Penn State University Harrisburg Campus Stadium and Restroom Building PSU Project # 00-08713.00

WMF project No.: 2022.138.00

ADDENDUM NO. 1 April 03, 2024

The following revised drawings ae attached to this addendum 01. C502

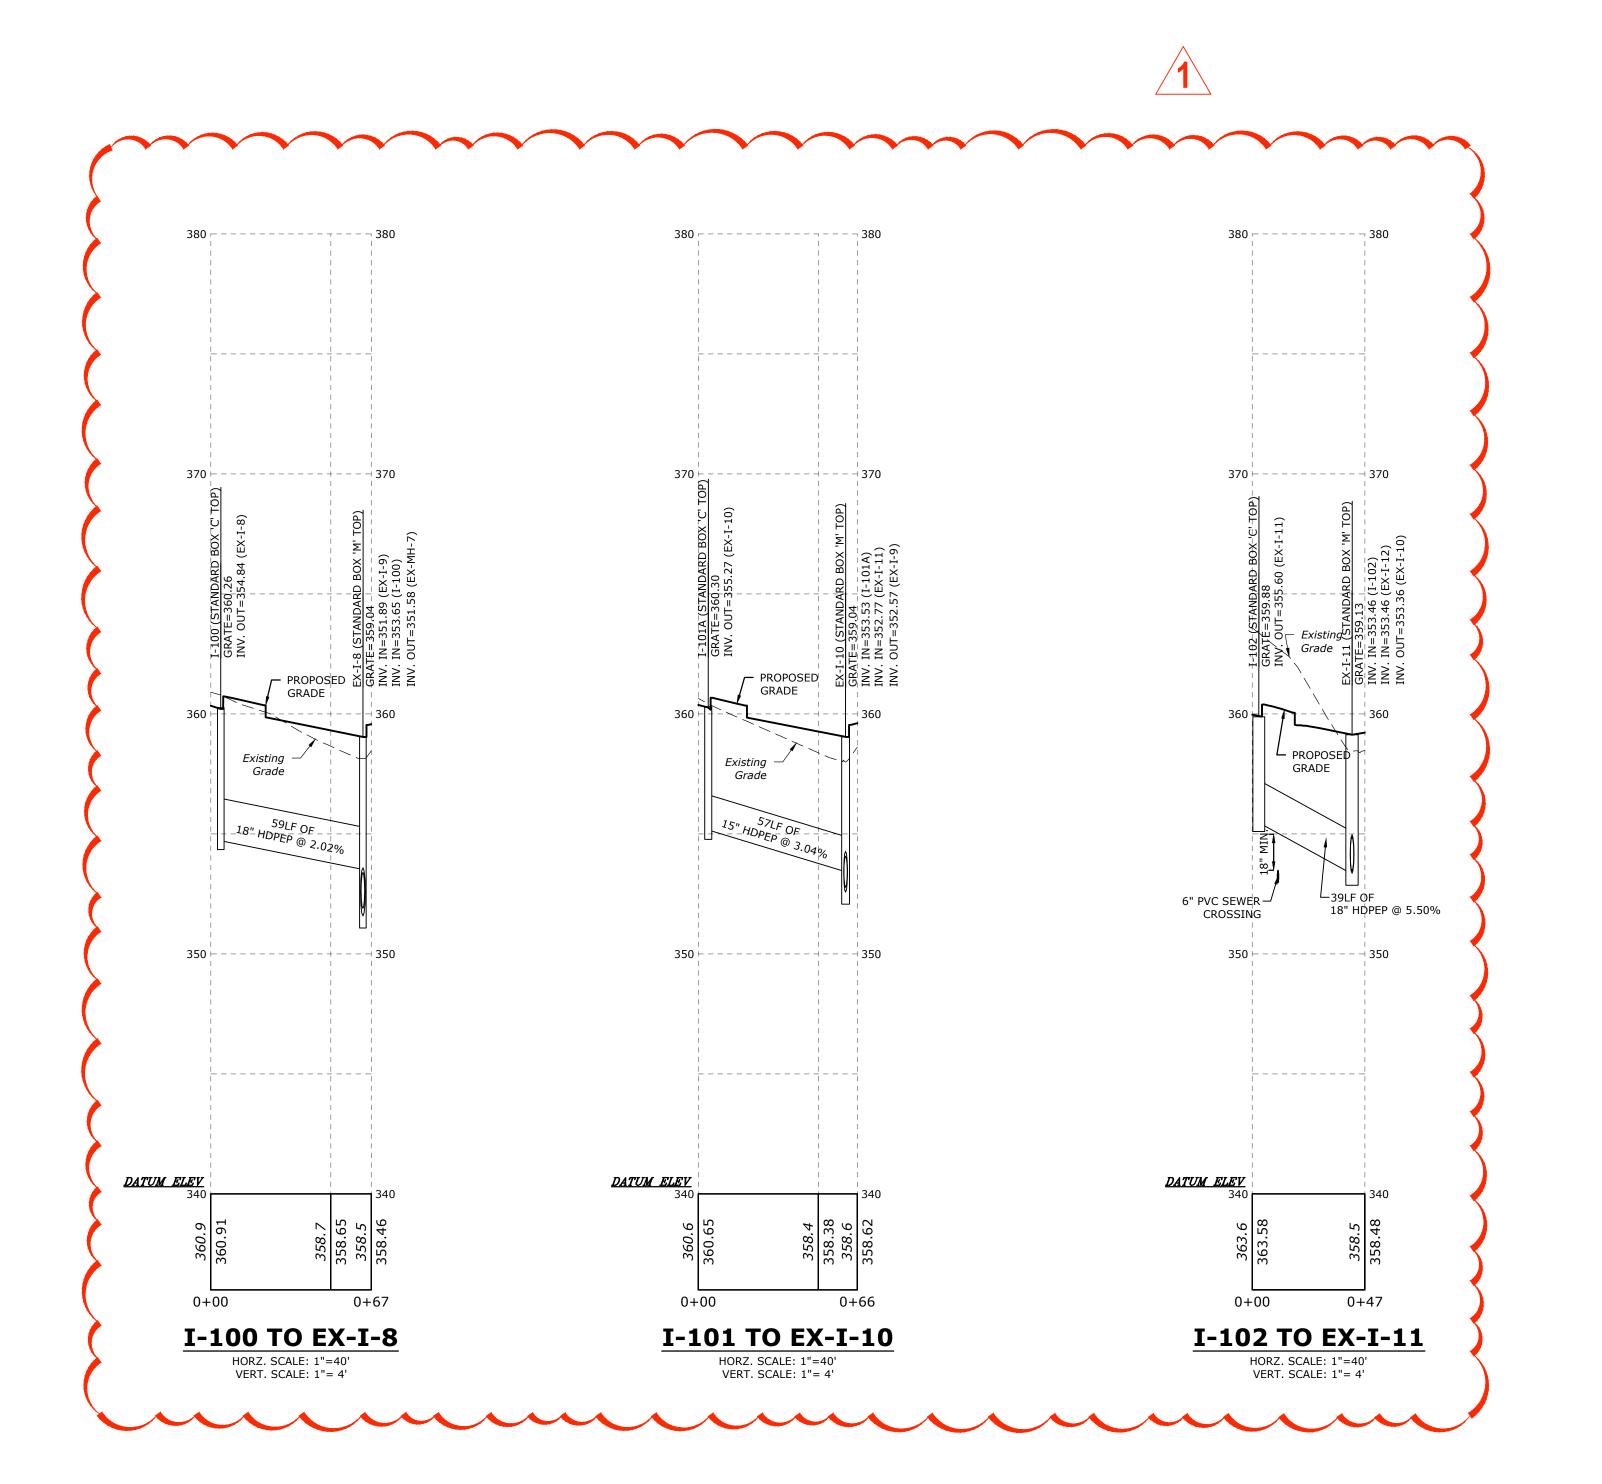
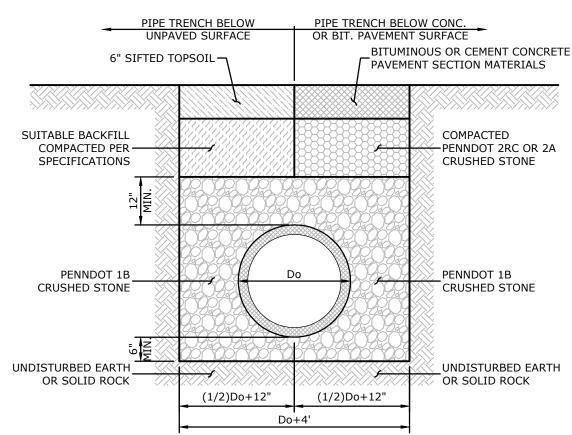
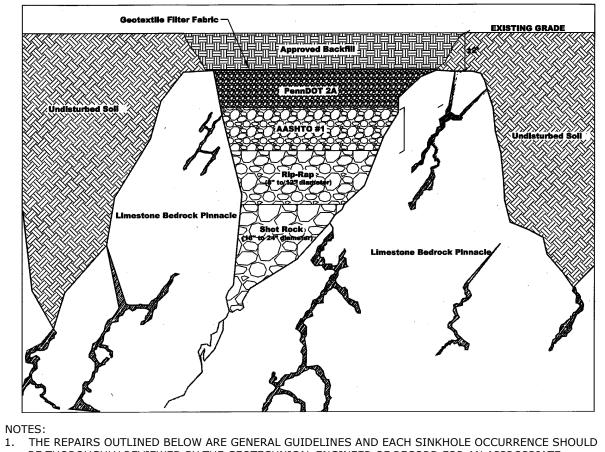
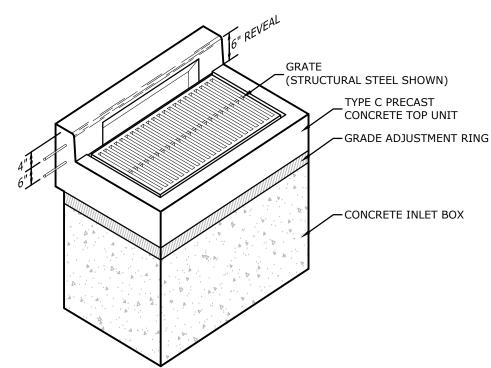
Question: Please provide profiles / inverts / top of structure for the proposed storm drain. Response: Revised drawing C502 is attached to this Addendum 01.
